**Commonwealth Edison**  
One First National Plaza, Chicago, Illinois  
Address Reply to: Post Office Box 767  
Chicago, Illinois 60690

December 2, 1985

Subject: Dresden Station Units 2 and 3  
Quad Cities Station Units 1 and 2  
Review of Fire Protection Requirements  
NRC Docket Nos. 50-237, 50-249,  
50-254 and 50-265

FIGURE 1

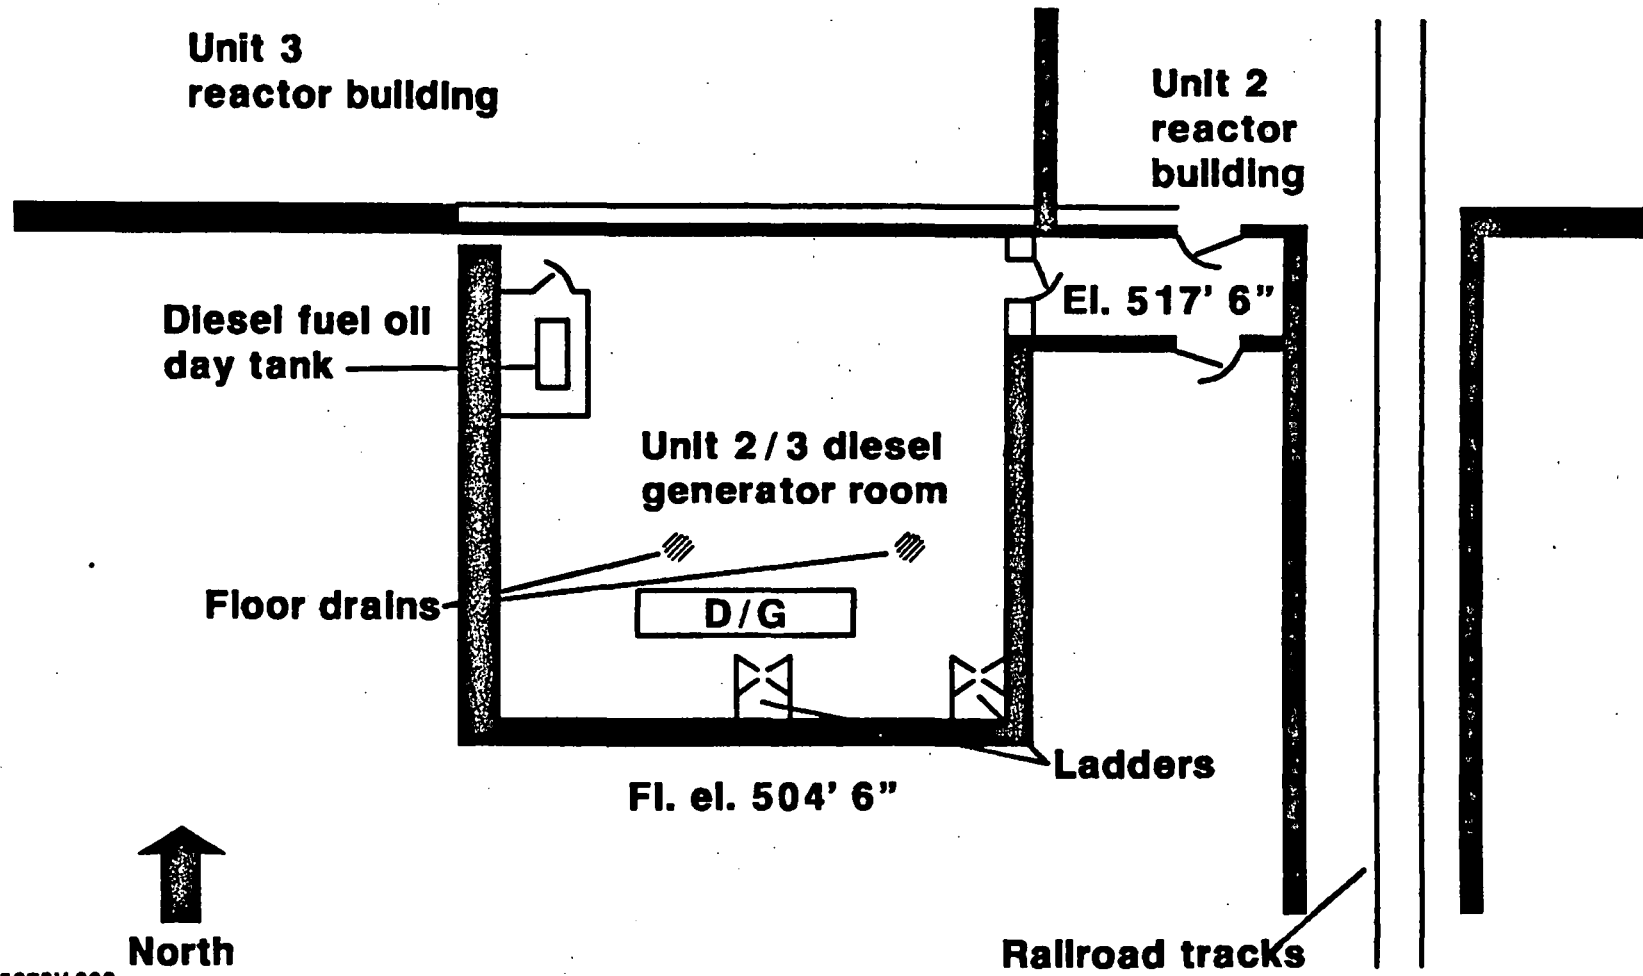
<u>ITEM</u>	<u>SER REFERENCE</u>	<u>DESCRIPTION</u>
3.1(a)	3.1.8	SER Section 3.1.8 states, "Fire doors will be provided...at the....diesel generator rooms." Fire doors were installed at the Turbine Building entrances to the DG2 and DG3 rooms. A fire door was not installed for the reactor building entrance to the 2/3 DG room through the secondary containment interlocked access corridor (heavy metal interlocked doors exist). Based on the brief description in the SER and previous correspondence, we believe a fire door was not intended here since this is an external door with no external combustible loads. The general policy used in the 1977 FHA was to install fire doors in external walls only when there was a clearly identified hazard outside. See Attachment 5 page 3 for the fire hazards analysis. See Figure 1.

3.1(b)	3.1.8	SER Section 3.1.8 states, "Fire doors will be provided...at the...diesel generator rooms." Since suppression exists in both the 2/3 DG and HPCI rooms, and two heavy metal doors are in place, a fire door was not intended and therefore not installed between the 2/3 DG room and the HPCI rooms. Refer to Section 2.3.9.7 of the 1977 FHA. See Attachment 5 page 3 for the fire hazards analysis. See Figure 1.

3.2	3.1.15	SER Section 3.1.15 states, "Curbs will be provided for the diesel generator room..." All doors in the DG rooms and Day Tank rooms have been provided with curbs except the entrance to the 2/3 DG room. A curb was not intended for this location since the entrance is 13 feet above floor level. See Attachment 5 page 3 for the fire hazards analysis. See Figure 1.

The diesel generator 2/3 room north wall separates this room from the Reactor Building (See Figure 1). This is a 3-hour rated fire barrier. The east, west and south walls and roof are exterior boundaries. These walls and roof are not fire rated. An unrated substantial metal door from the 2/3 diesel generator room eastwall opens to the secondary containment interlock corridor (See Figure 1). A door from the Unit 2 reactor building and from the exterior also opens into this corridor. The floor is a secondary containment boundary which separates the diesel generator 2/3 room from the Units 2 and 3 HPCI rooms. The floor is not fire rated. Unrated double doors provide access from the 2/3 diesel generator room to each HPCI room. The safety-related equipment in the diesel generator 2/3 room includes the 2/3 diesel generator, fuel oil transfer pump, and vent fans.

The Unit 2 reactor building door and 2/3 diesel generator east door, which open into the secondary containment interlocked access corridor, are considered exterior doors. These are heavy metal doors which are electrically interlocked. There is no continuity of combustibles across the access corridor. Furthermore, the access corridor is 13 feet above the 2/3 diesel generator room floor. This difference in elevation prevents any possibility for combustible liquid from communicating from the DG 2/3 room to the Reactor Building. Finally, the DG 2/3 room is protected with complete thermal fire detection and total flooding CO<sub>2</sub>. Consequently, it is unlikely that a design basis fire in the 2/3 diesel generator room would spread from the DG 2/3 room to the Unit 2 reactor building.

There are two hollow metal doors in series leading from the 2/3 diesel generator room into each HPCI room (4 doors total). These doors are normally closed and provide a secondary containment boundary. There is no continuity of combustibles through these double doors. The maximum flooding height due to 750 gallons (day tank capacity) of oil being discharged into the room would be approximately one-half inch. This assumes both four inch drains are completely blocked. The existing one-half inch threshold at the HPCI access doorways in conjunction with the existing drains provide adequate protection in the event of an oil spill. Figure 1 shows that an oil line break could not directly impinge an access door. The two four inch drains divert oil into the HPCI room trench which empties into the HPCI room sumps. However, the 2/3 diesel generator rooms and each HPCI room have complete automatic detection and suppression. The HPCI rooms are protected by a preaction water system. Consequently, a fire originating in either room would be promptly detected and suppressed. Additionally, the existing separation between these rooms provides a substantial barrier to fire spread.

FIGURE 2

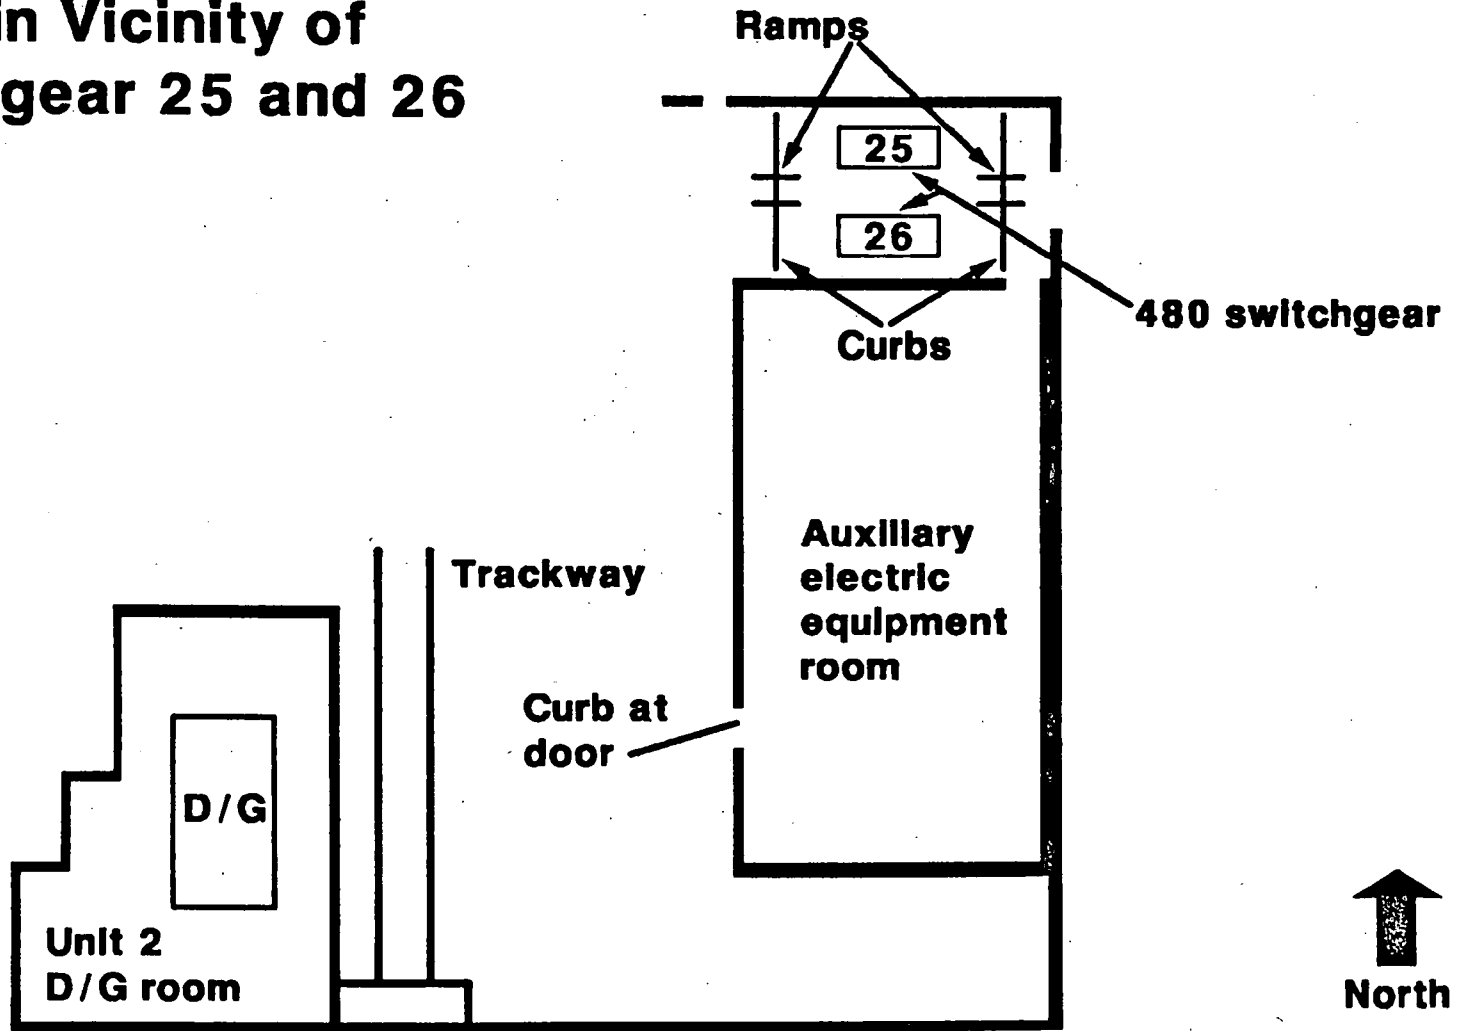
<u>ITEM</u>	<u>SER REFERENCE</u>	<u>DESCRIPTION</u>
3.4	3.1.15	SER Section 3.1.15 states, "Curbs will be provided at the entrance of the AEER room." The required curb was installed at the West door to the AEER to protect from potential transient combustibles in the Unit 2 trackway. A curb was not installed at the North door since curbs exist around adjacent 480V bus 25 and 26 transformers. These transformers are curbed and are the only fixed hazard in the vicinity. The north door does not access the Unit 2 trackway. See Figure 2.

FIGURE 3

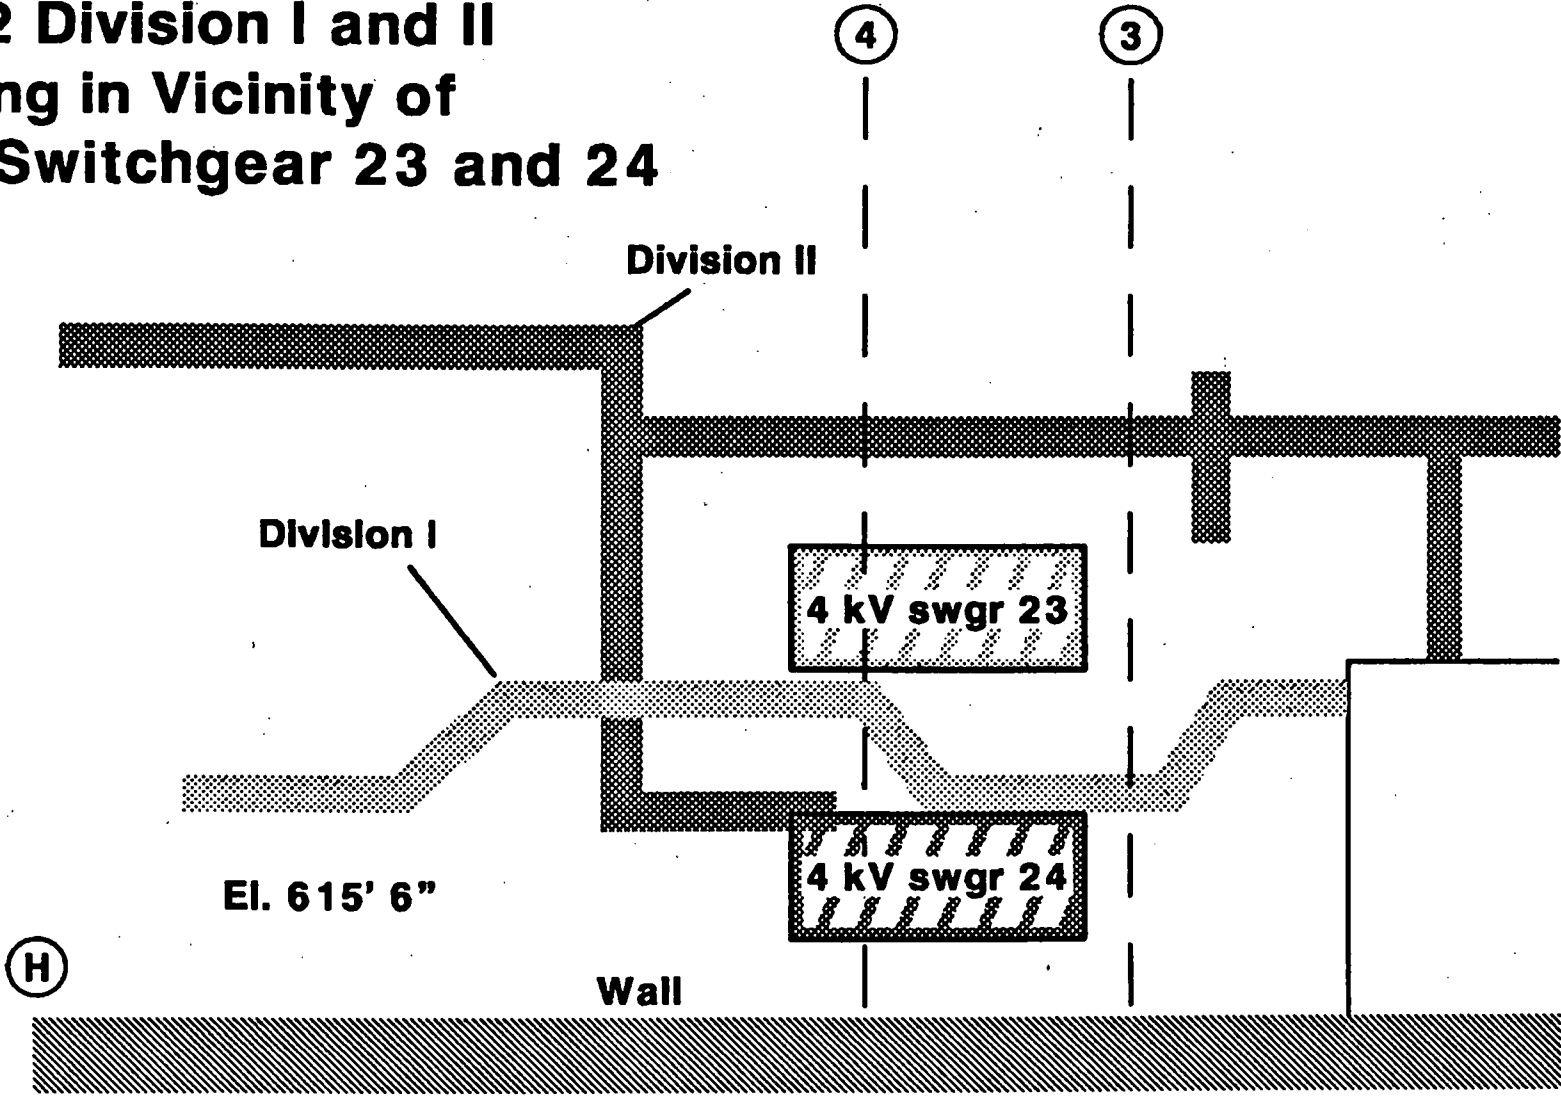
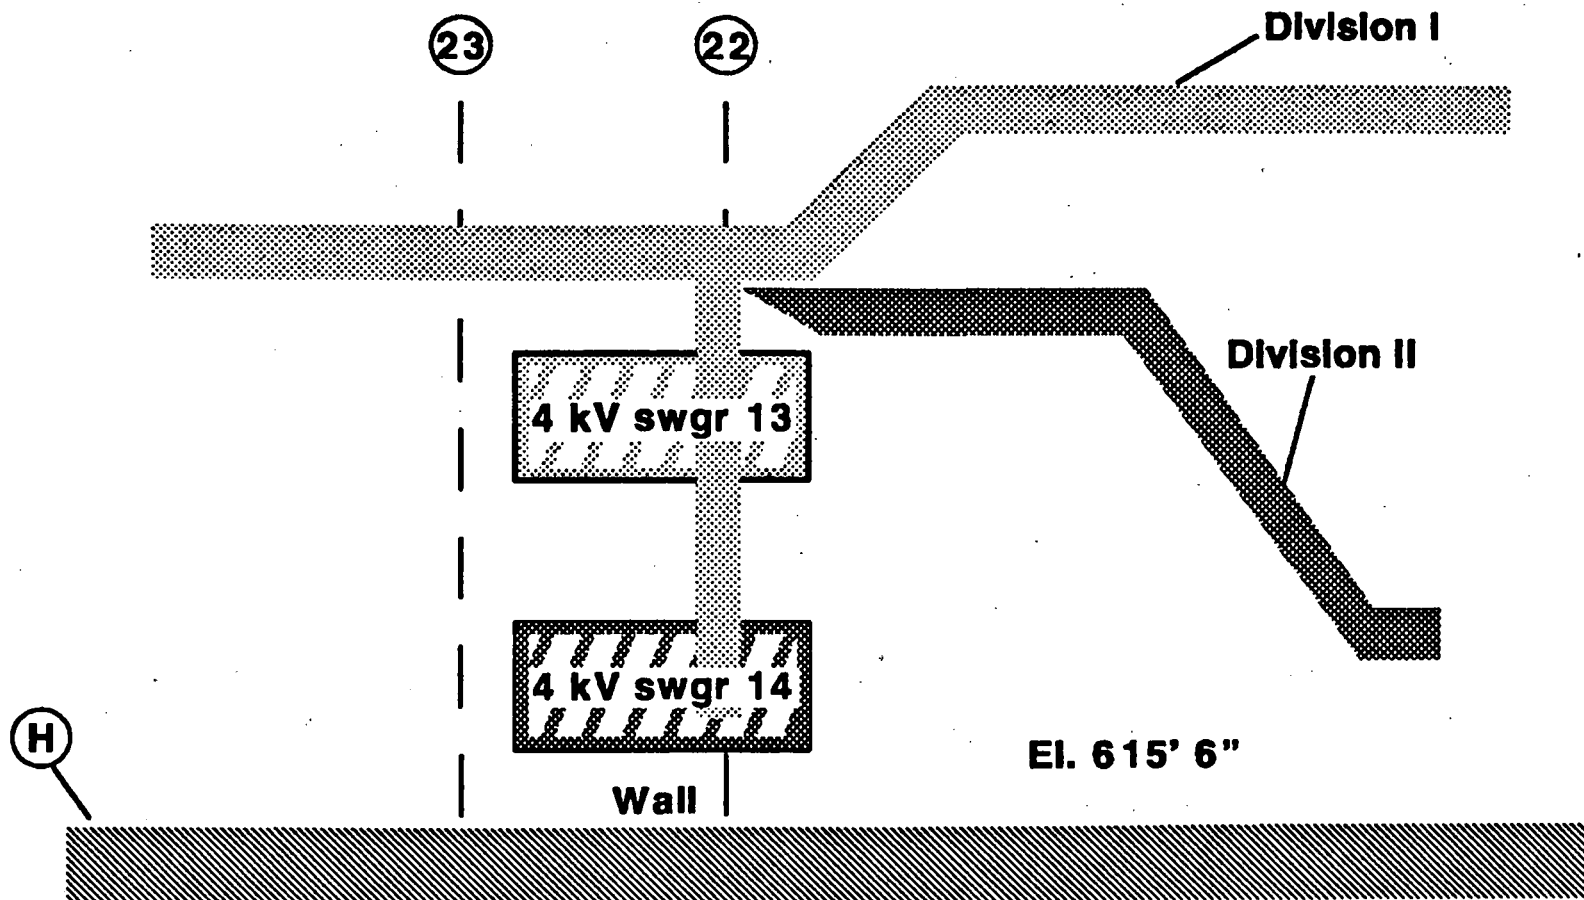
<u>CATEGORY</u>	<u>ITEM</u>	<u>SER REFERENCE</u>	<u>DESCRIPTION/RESOLUTION</u>
2	2.3	3.1.4	<p>SER Section 3.1.10 states, "The top of electrical cabinets, switchgear, and motor control centers will be protected to reduce the potential for water damage from hose streams used to combat cable fires as noted...for the following areas: (1) Auxiliary Electric Equipment Room, (2) Reactor Building Mezzanine Floor, (3) Reactor Building Ground Floor, (4) Turbine Building Mezzanine Floor, and (5) Turbine Building Main Floor.</p> <p>Water protection was provided as noted for all areas except the Turbine Building Mezzanine Floor. For the Turbine Building Main Floor six foot vertical water shields were installed at the motor generator (MG) sets to protect the 4kV switchgear from a discharge of the foam system protecting the MG sets. This vertical shield was installed in place of the overhead canopies mentioned in the FPSE. For the Turbine Building Mezzanine Floor, the FPSE indicated that protection from water should be provided for 4kV buses 13, 14, 23 and 24. This would reduce the potential for adversely affecting a Division II bus when extinguishing a fire in overhead or nearby Division I cable tray or adversely affecting a Division I bus when fighting a nearby Division II cable tray fire.</p> <p>The only safe shutdown equipment fed by buses 13, 14, 23, and 24 are the residual heat removal service water (RHRSW) pumps. However, a mechanical cross-tie with the other units Division I RHRSW piping allow the other unit to provide Division I RHRSW in the event that both 4kV buses 13 and 14 or 23 and 24 are affected by fire/water. In order to utilize this Division I mechanical crosstie, both units 4kV buses 13-1 and 23-1 must be powered. A modification was installed in late 1984 to permit this to be done without a hot shutdown repair. This repair would be required to be performed within 3 hours. Consequently, loss of these buses do not prevent safe hot or cold shutdown. The top of these buses have ventilation openings. However, installation of a canopy is impractical due to the congested (e.g. HVAC and conduit) areas above. Request relief from commitment based on existence of both Division I and Division II (recently installed) RHRSW mechanical cross-ties which meet the commitment intent. See Figures 3 and 4.</p> <p>Interim Action: A temporary cover has been provided for these buses.</p>
